## AP 227 DIS Issues Log

**Issue Number:** 1      **Alt. Numbers:** FRANCE-227-DIS-001      **Issue Date:** 23-Jan-98

**Issue Title:** Reference to PLib Dictionaries and Libraries in Clause 1

Example 2

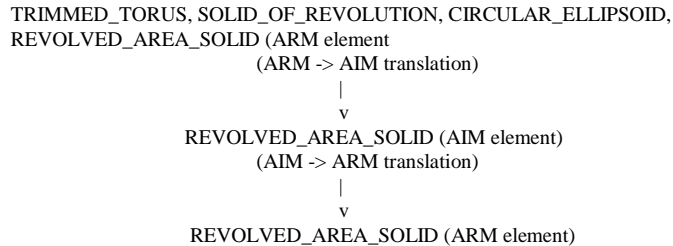
**Comment**    **Date:** 20-Jun-97    **Commentor:** Nikolay Shul    **Action:**

Digest first, details (for these interested) below...
